May 1, 2018  
MTE File No.: C33886-100

**Response to Township Peer Review Comments, August 4, 2017  
Re: Level 1 and Level 2 Hydrogeological Investigation Report,  
Proposed Freymond Quarry**

**Deep Groundwater Flow Map - Dec 1, 2017**

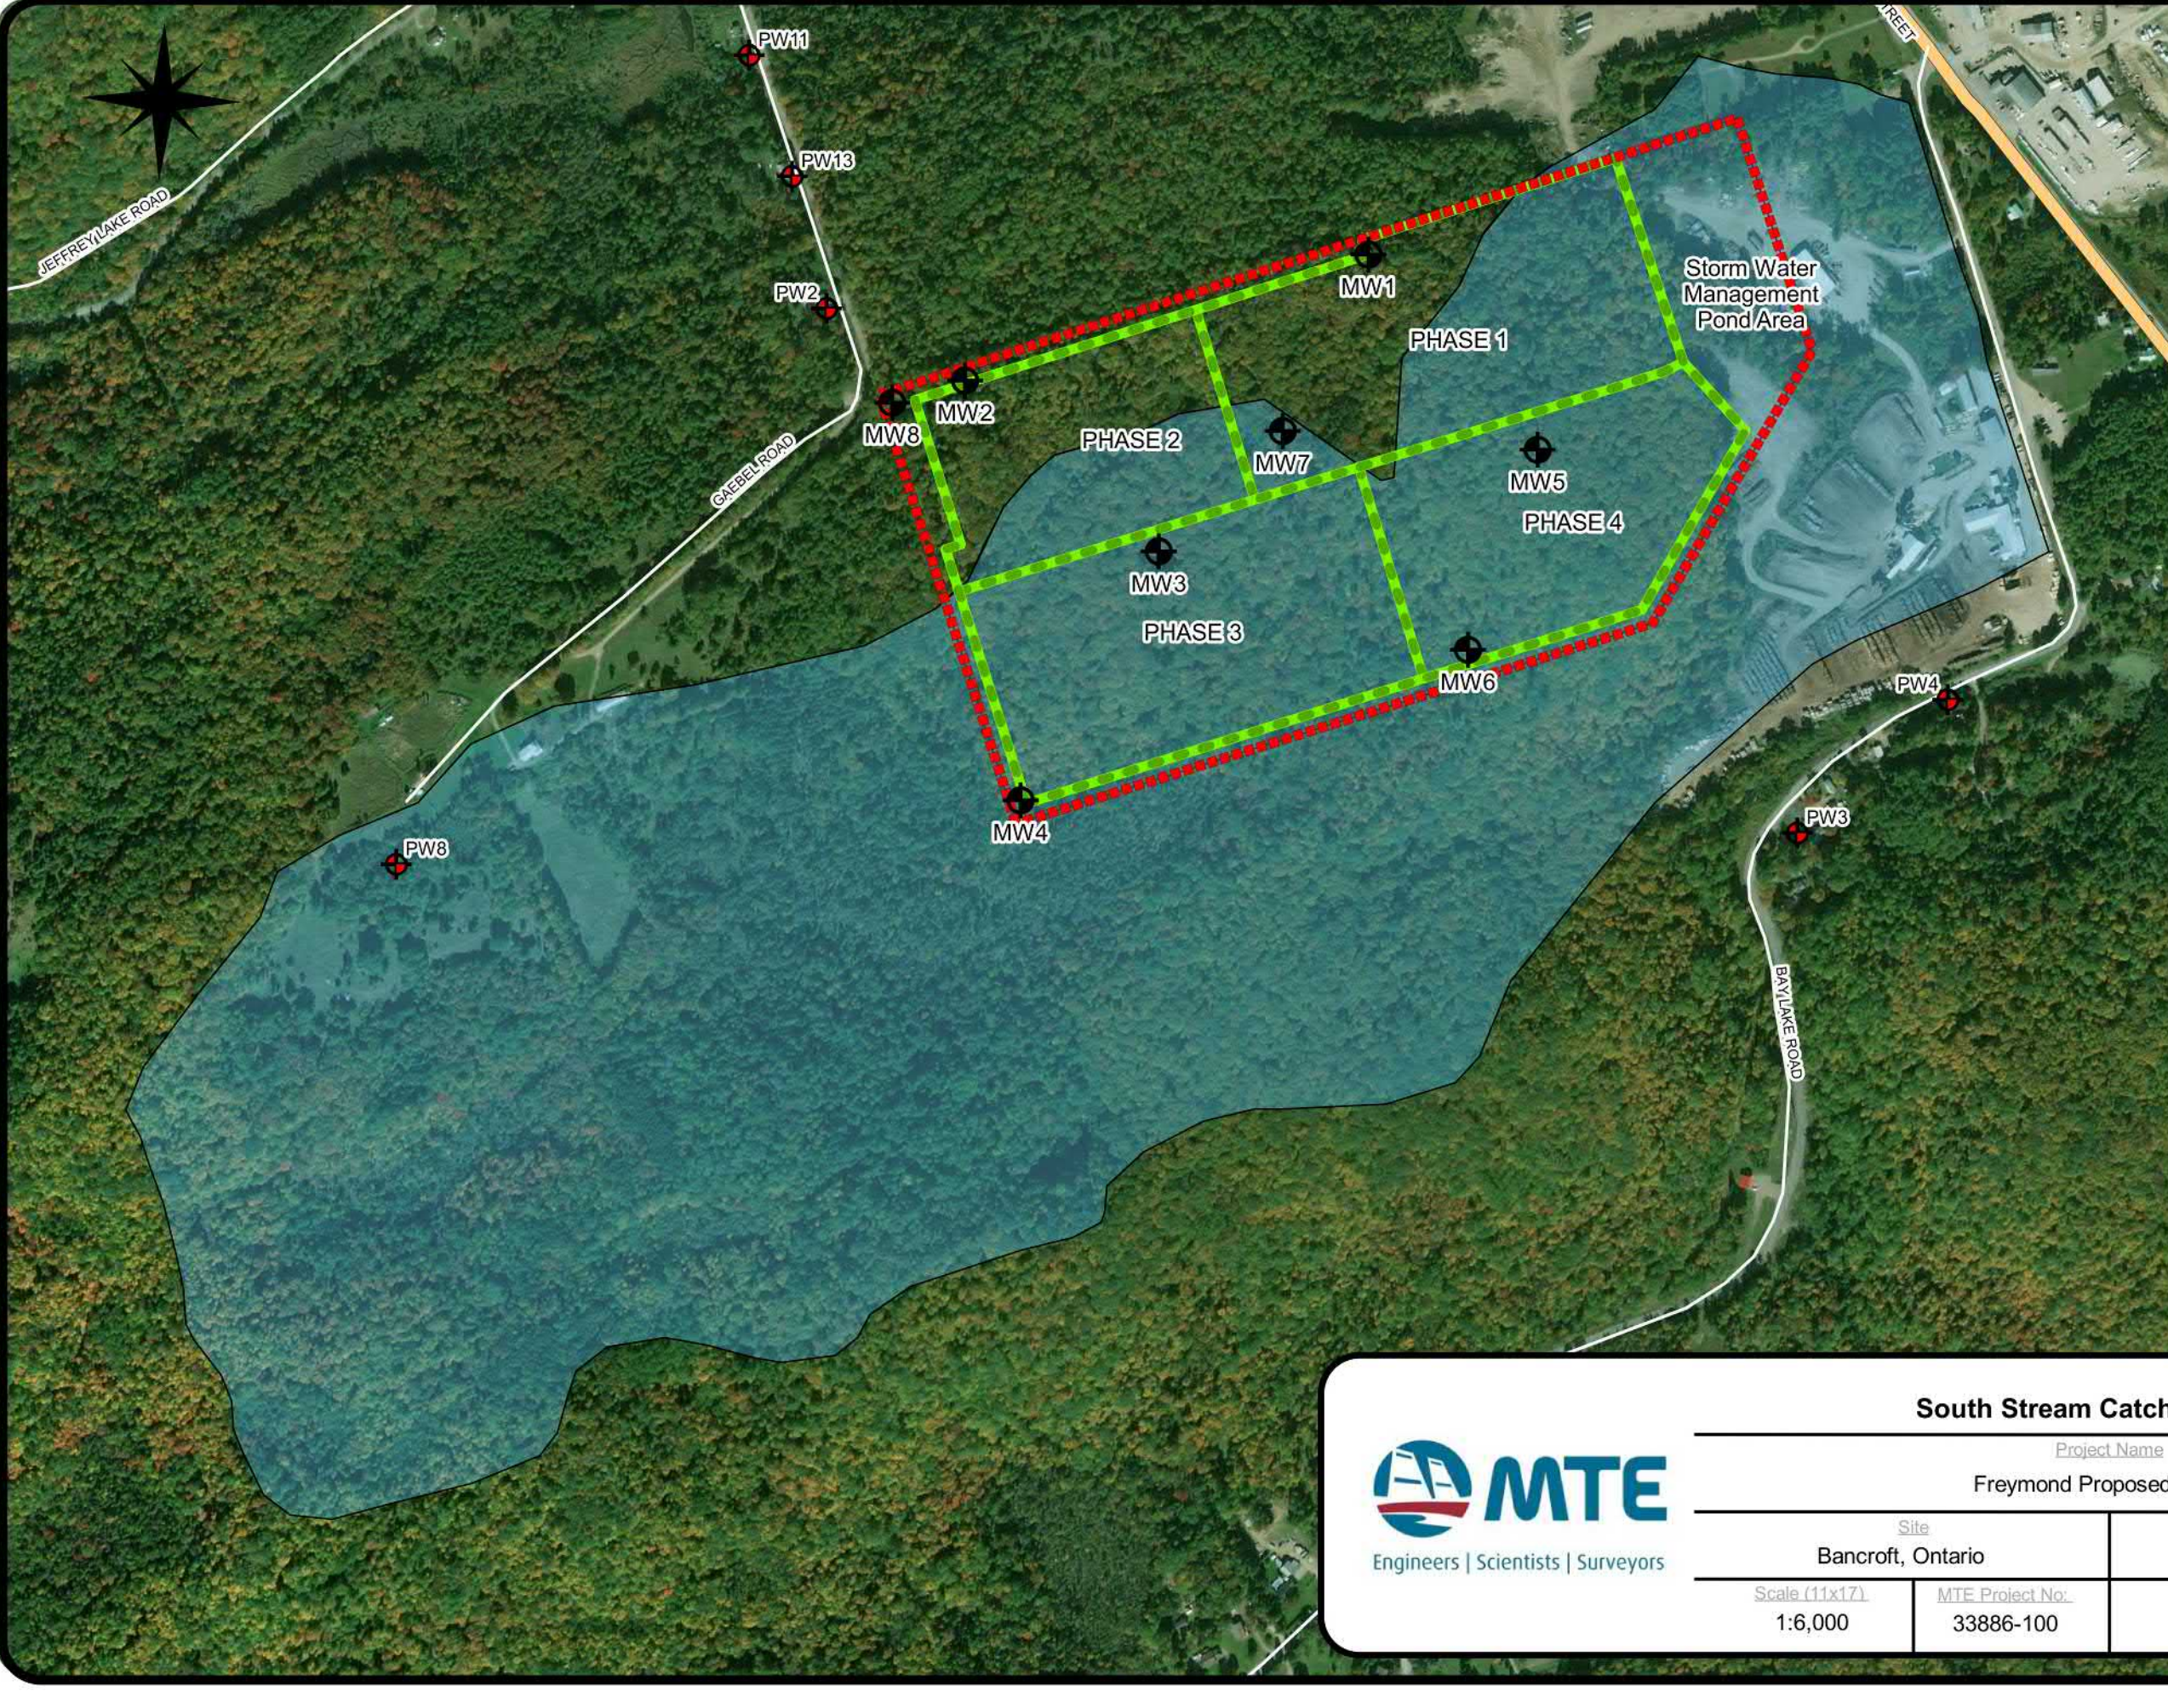
**Comment Number 6:** *The methodology of the Investigation effectively identifies wells, surface water features and flows, topography, and drainage. Seven boreholes (Monitor Wells) are constructed within the proposed extraction area. The monitor well in the centre of the property was constructed by diamond drill coring, and the core logged. Cuttings from the other boreholes were not logged. Groundwater conditions in the monitor wells are documented. Groundwater flows are modelled using published values for typical bedrock materials and not from values determined on site.*

MTE's 2016 Level 1 and Level 2 Hydrogeological Report included two groundwater flow maps (shallow & deep) which were created using water level data taken from on-Site wells. The groundwater gradient calculated from these maps was 0.04 m/m for the shallow system and 0.08 m/m for the deep. Two

additional groundwater flow maps using water level measurements taken on December 1, 2017 can be seen in **Figures 1 & 2**. Groundwater gradients calculated based on the 2017 data were comparable to those values calculated based on 2014 measurements.
